Did You Know?

Improvements to NAPA Echlin GM 6 & 8 Cyl. Caps

New Aluminum Terminals

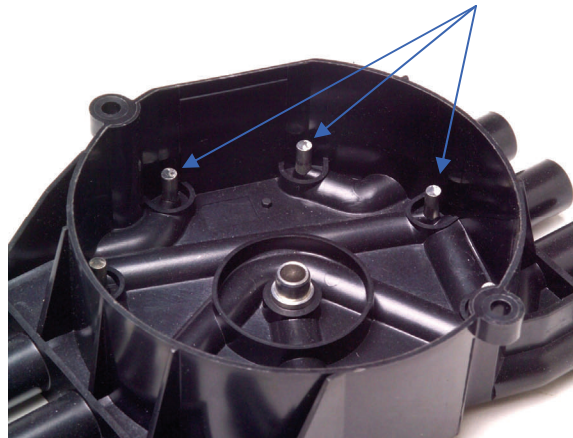
NAPA Echlin has made the following improvements to compensate for the faulty OE design. Both the RR207 and RR253 will now be manufactured with aluminum terminals. Due to the OE distributor flaws and corrosive environment, in these instances, aluminum will actually provide a longer service life than the brass. Additionally, both numbers will now use a special formulation manufactured from a polyester base plus a unique blend of mica particles and glass fibers. This improvement results in superior performance due to the higher dielectric strength of the cap.
